**ADDENDUM NO. 4
CITY OF PEORIA
RESERVOIR BOULEVARD ADA IMPROVEMENTS
AUGUST 23, 2024**

Re: Addendum for Bid Package, **Reservoir Boulevard Ada Improvements**, Peoria, IL

This Addendum modifies the specifications and quantity of SOLAR-POWERED FLASHING BEACON ASSEMBLY (COMPLETE).

SCHEDULE OF QUANTITIES (2 OF 2)

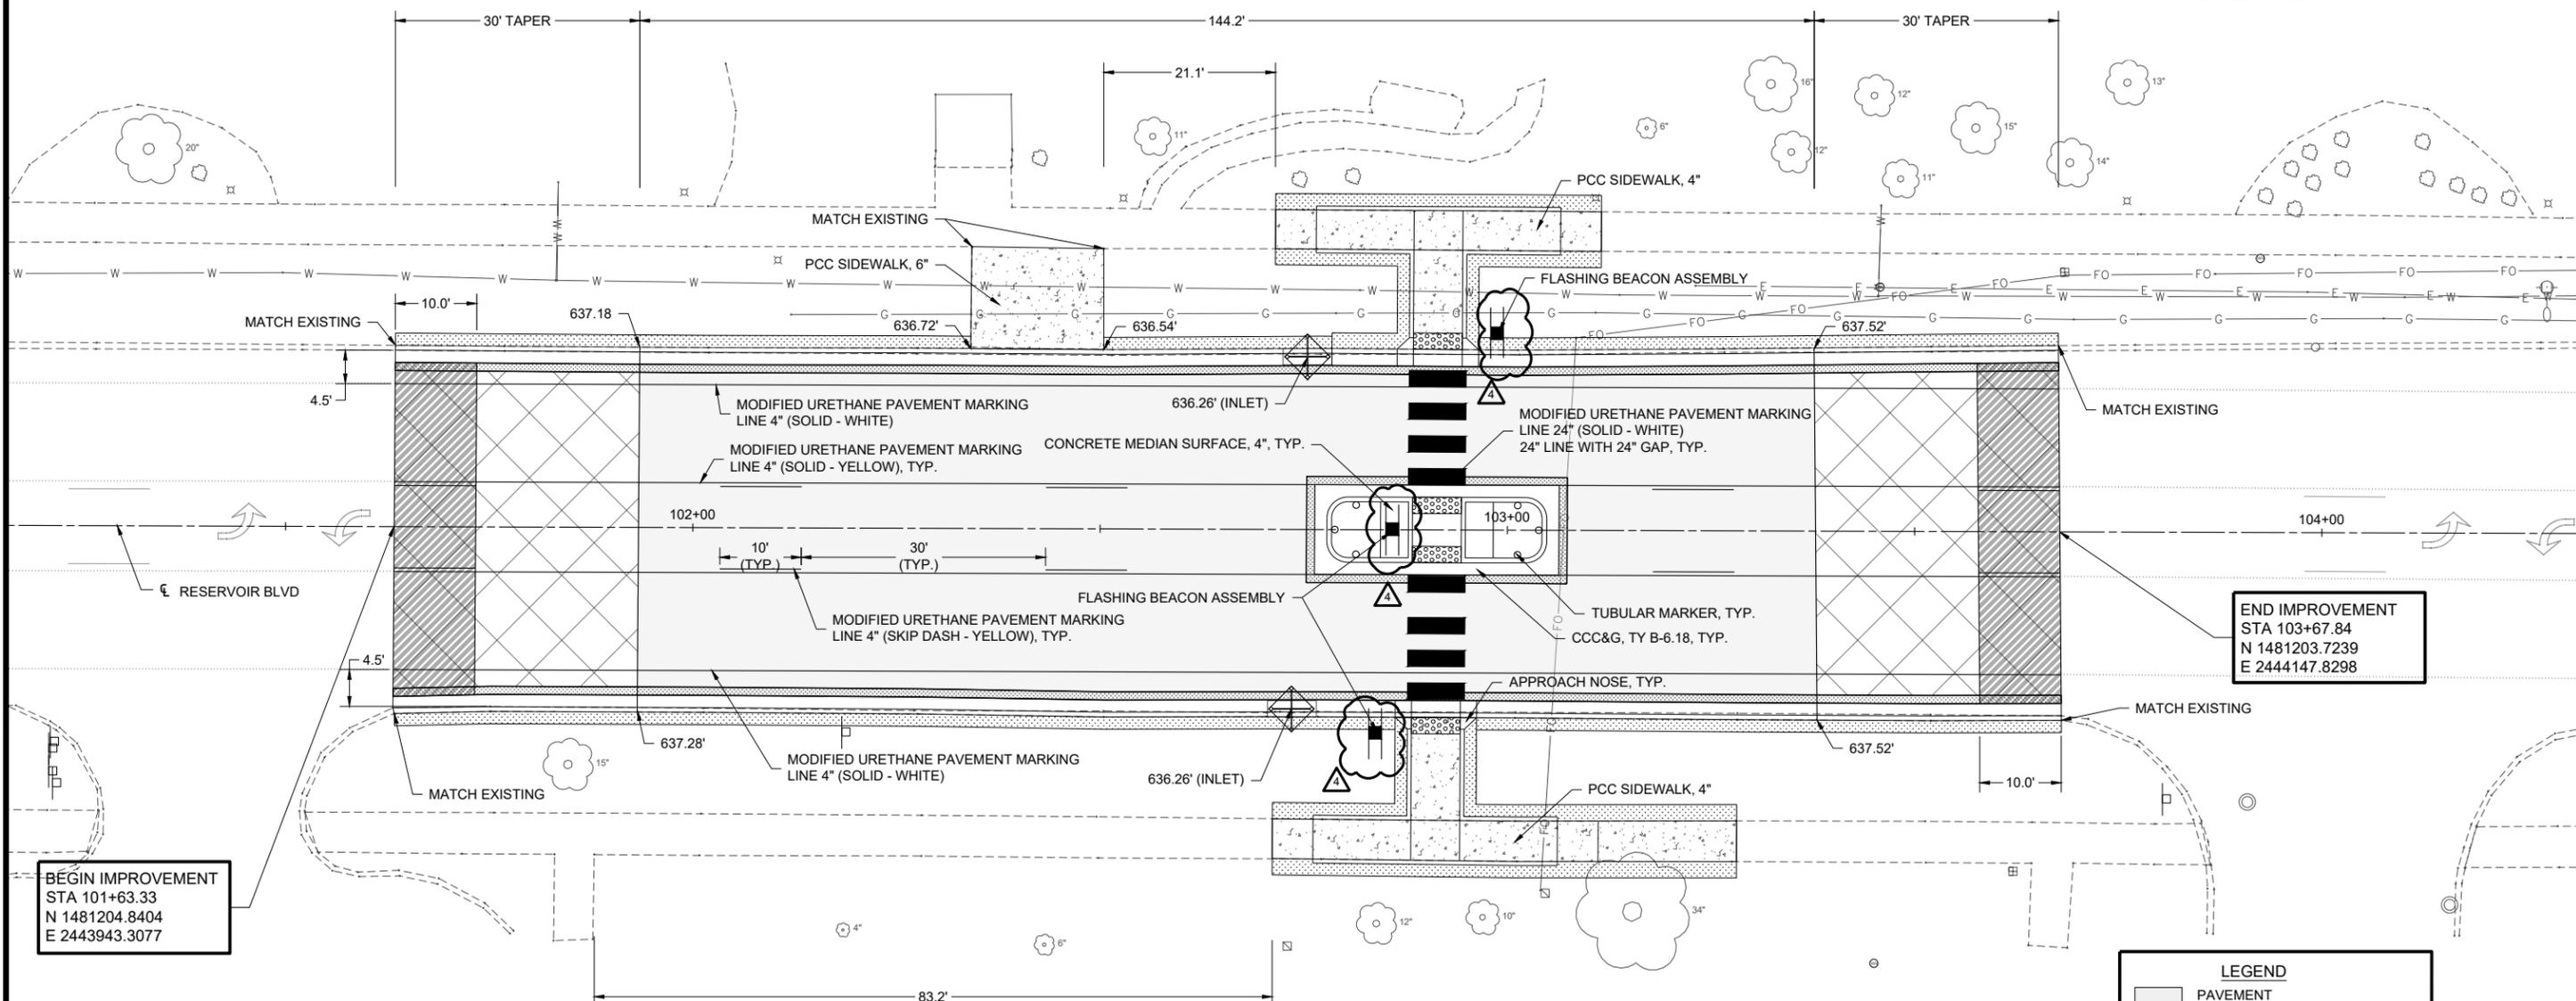
1. Replace Sheets 3, 7, and 9 of the plan set with the attached sheets addressing an additional SOLAR-POWERED FLASHING BEACON ASSEMBLY (COMPLETE).

SOLAR-POWERED FLASHING BEACON ASSEMBLY (COMPLETE)			
LOCATION			X0326899
STATION	OFFSET	SIDE	EACH
RESERVOIR BLVD			
102+83.6	25.0'	RT	1
102+85.8	0'	CL	1
102+98.7	25.0'	LT	1
TOTAL			3
USE			3
